ADDENDUM #1

PROJECT MANUAL FOR: CP221951 UMPB Ground Floor Renovation

CP221951 UPMB Addendum # 1

PROJECT: UPMB Ground Floor Renovations
PROJECT NO: MUHC – CP221951, R&B - 1202.0011414.000
DATE: September 16, 2022
BY: Tori Gillespie, Chris Philipp
RE: Addendum #1
DWG REF: See below
SPEC REF: See below
CC: Central File

G100
CODE PLAN + IC

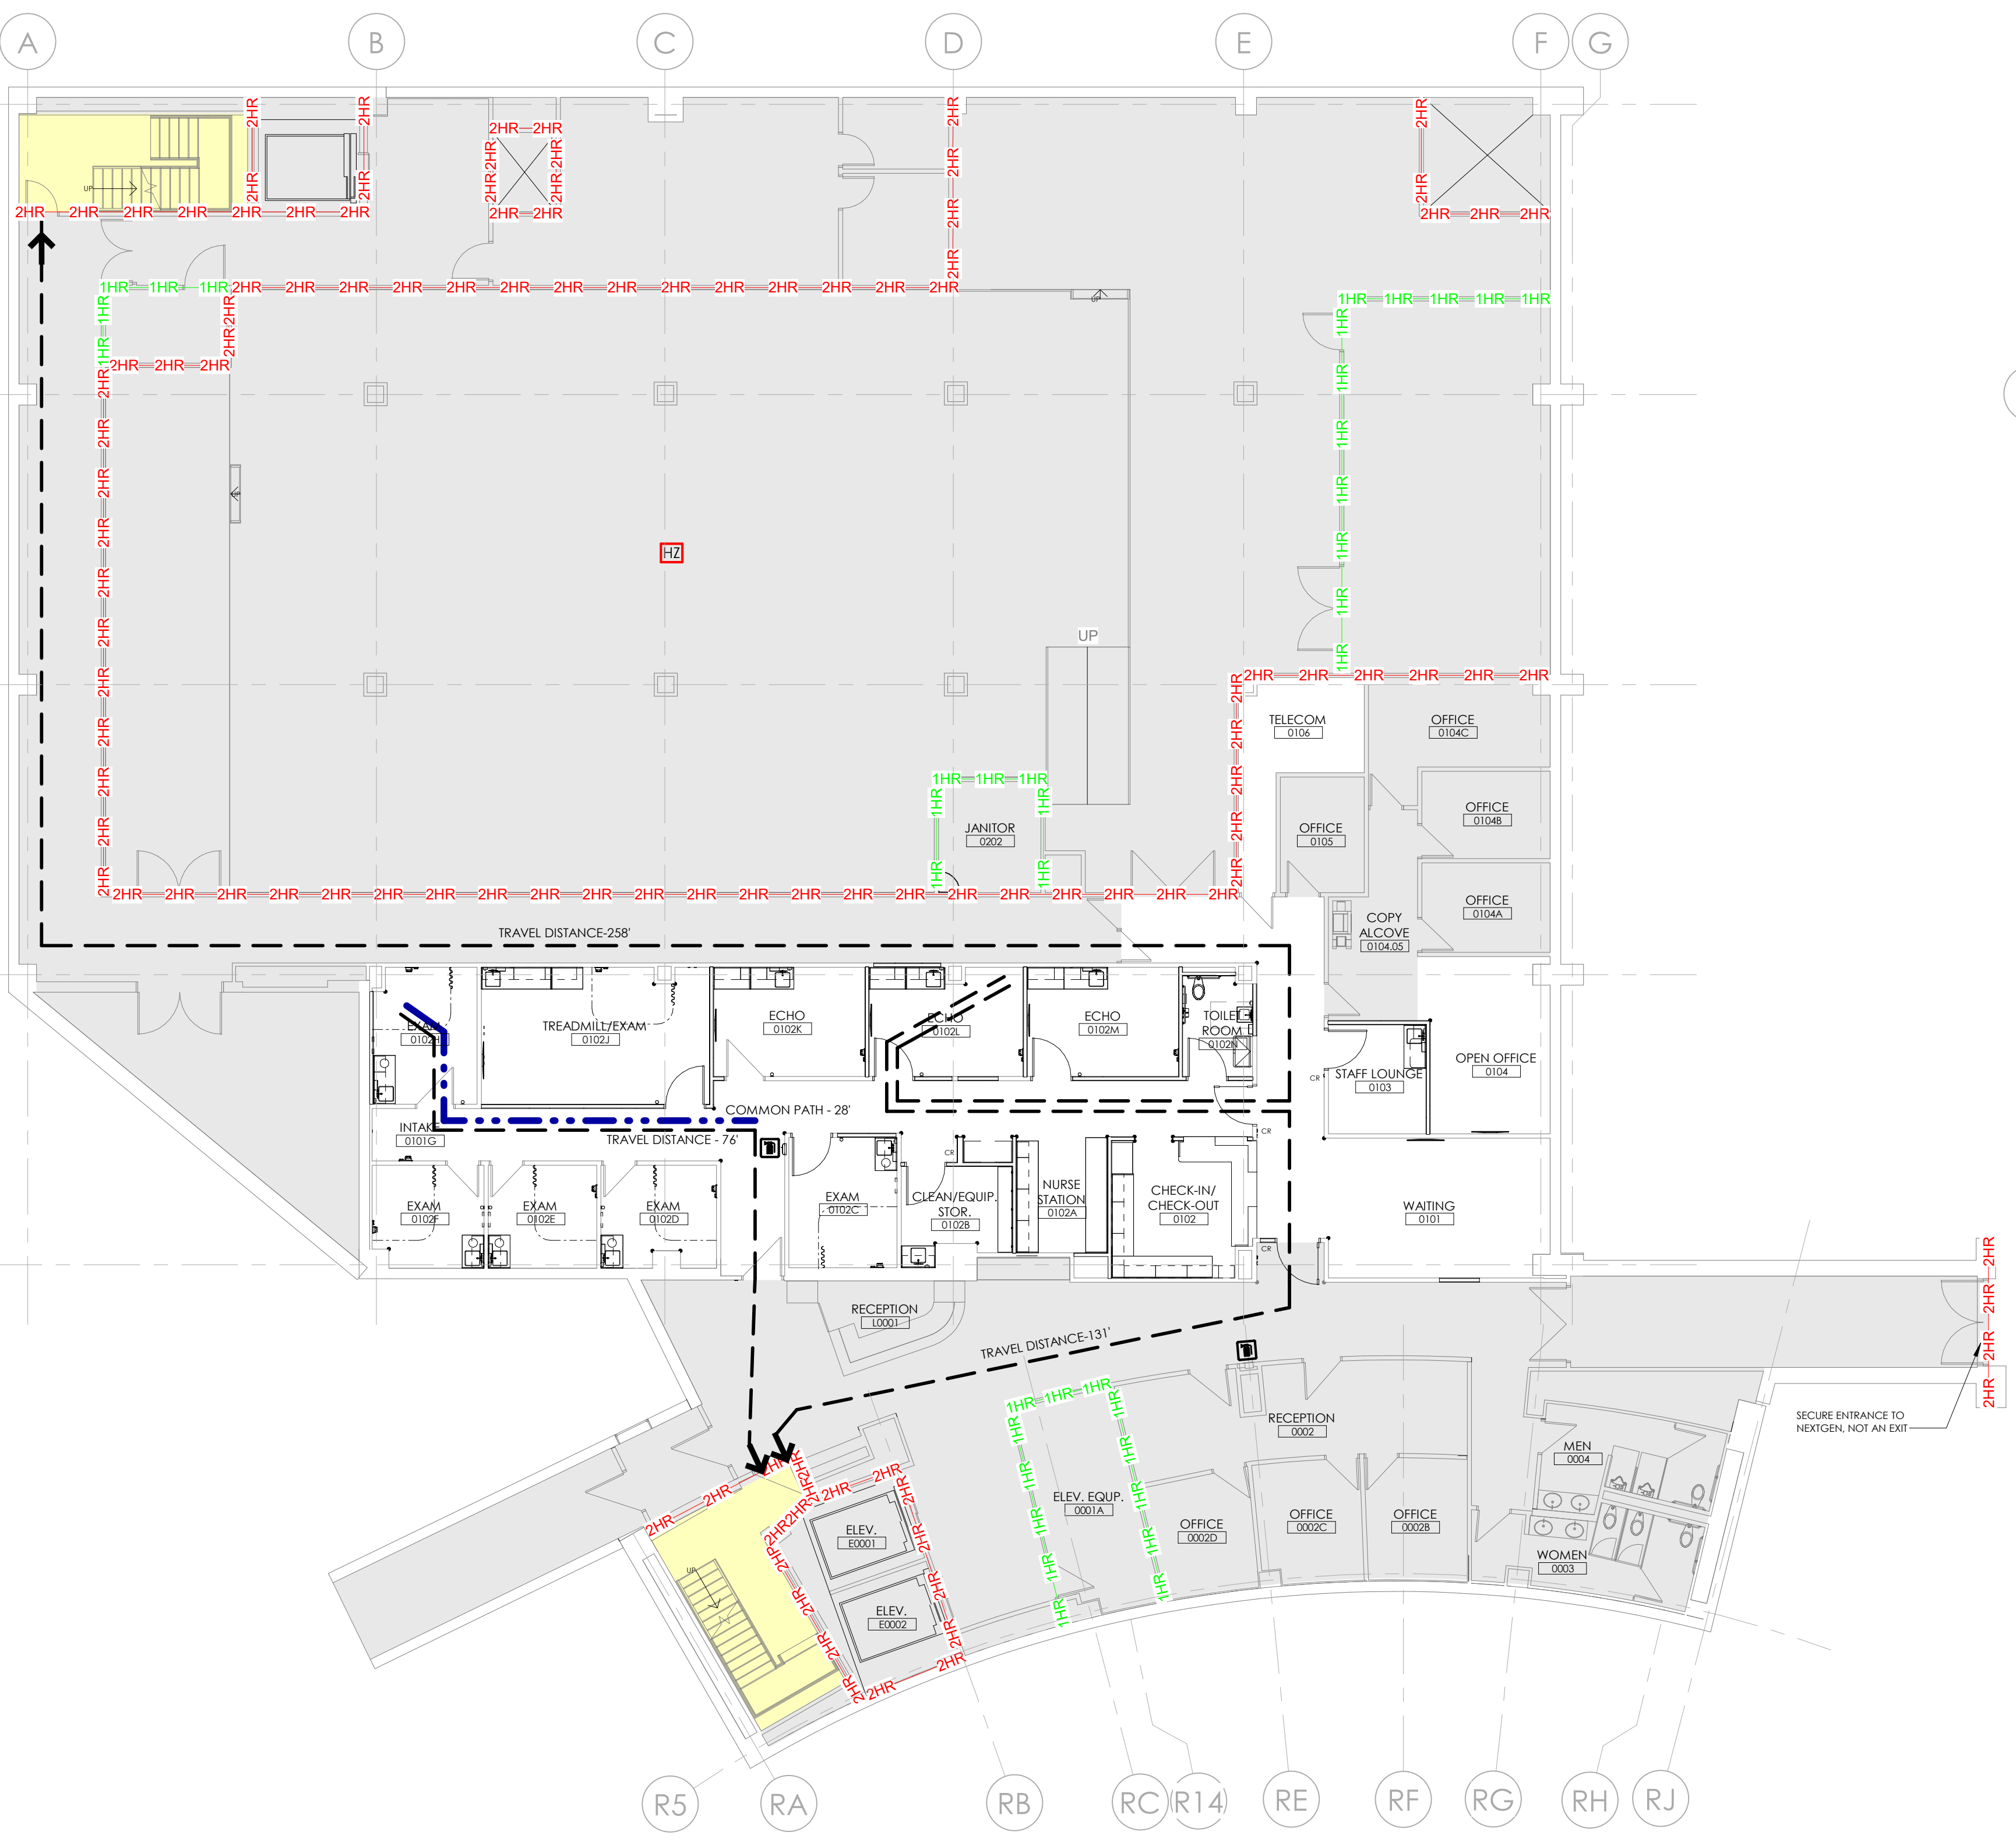
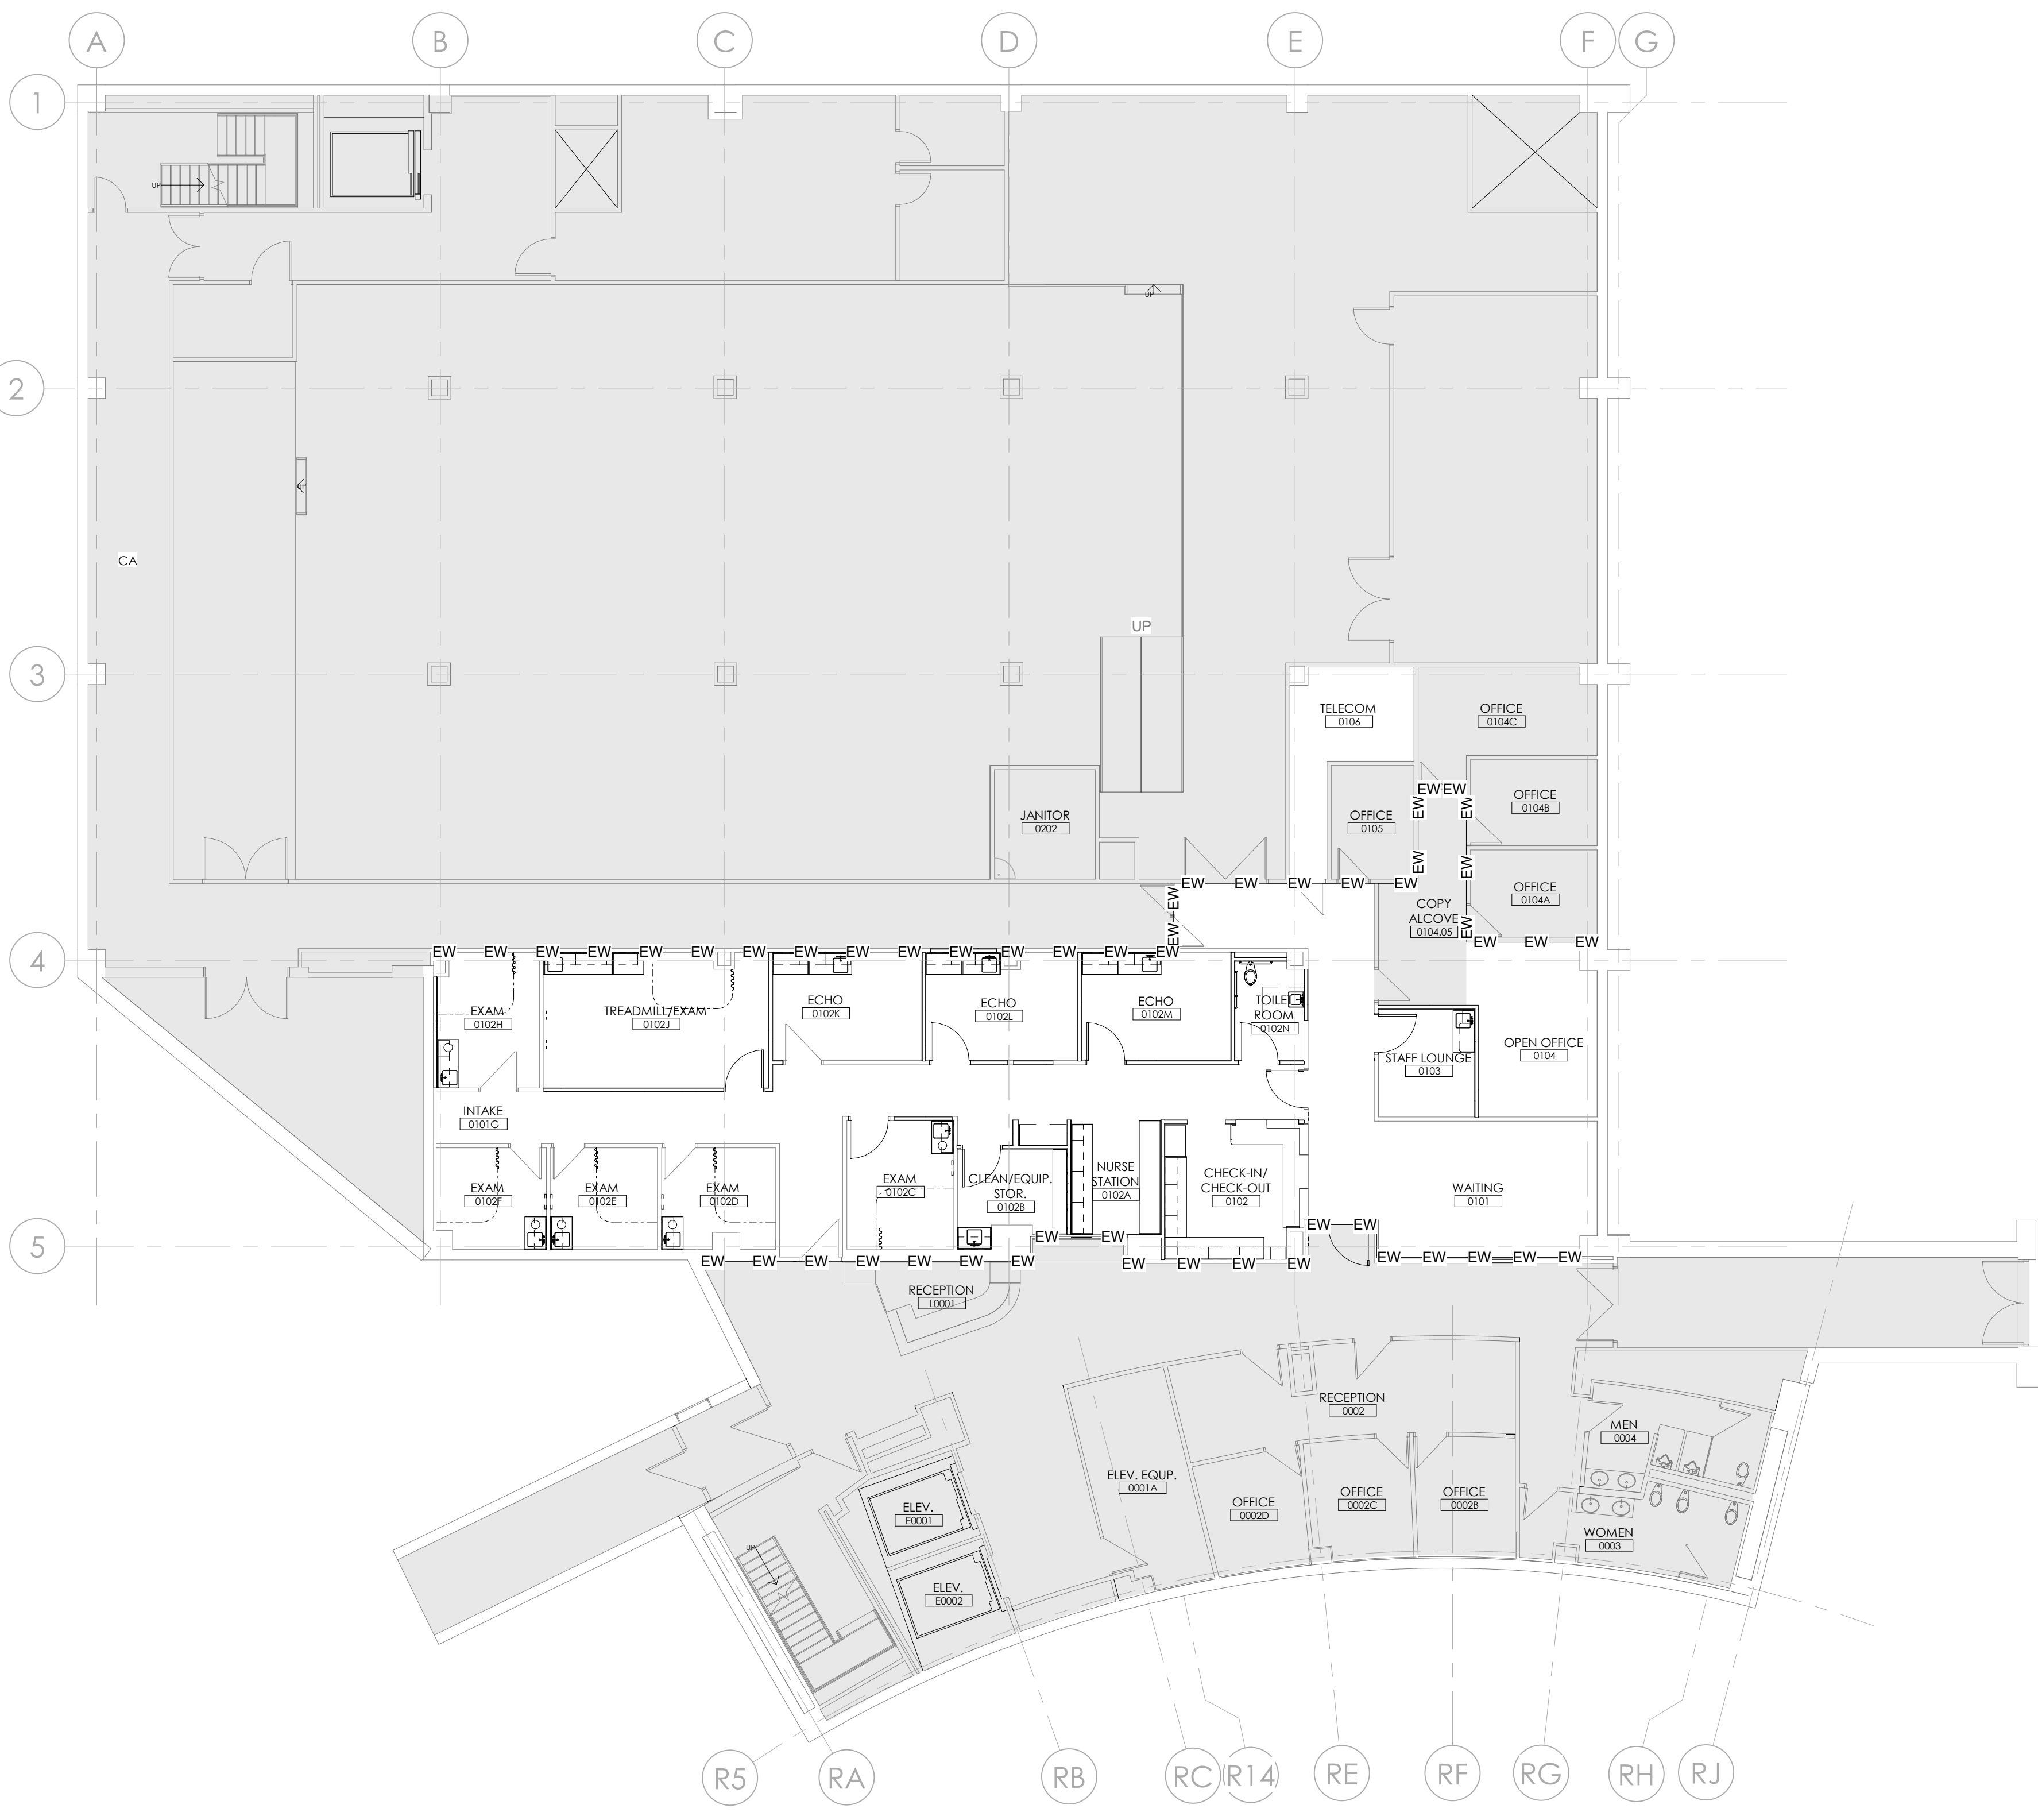
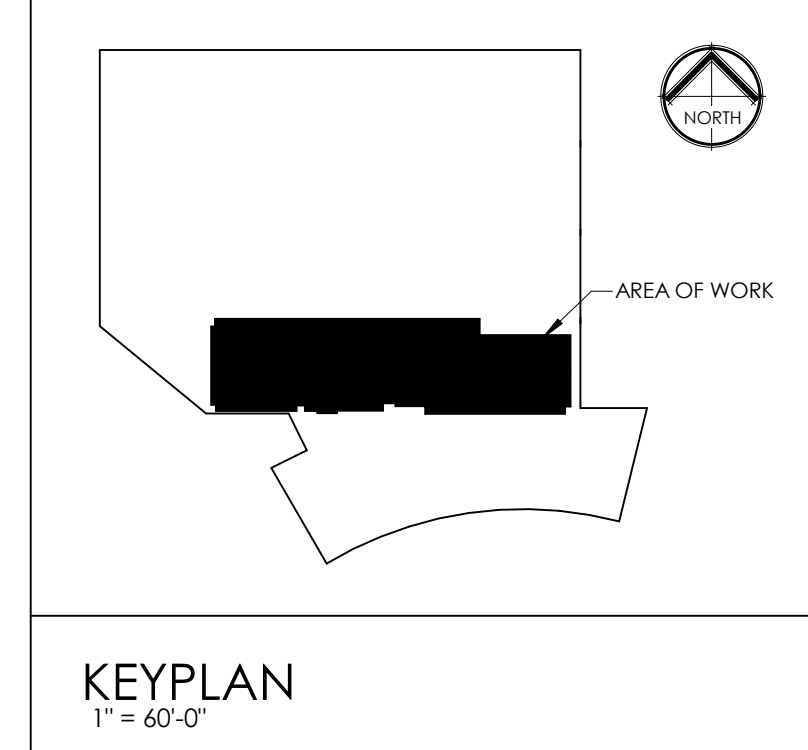
1. G100 – Added building risk category to Code Information per GBA comment. Grey hatch label updated to "No work, U.N.O."
2. G101 – Grey hatch added to Floor Plan Legend.
3. A100 – Grey hatch added to Floor Plan Legend.
4. A101 – Grey hatch added to Floor Plan Legend.
5. A200 – Grey hatch added to Reflected Ceiling Plan Legend and Finish Legend.
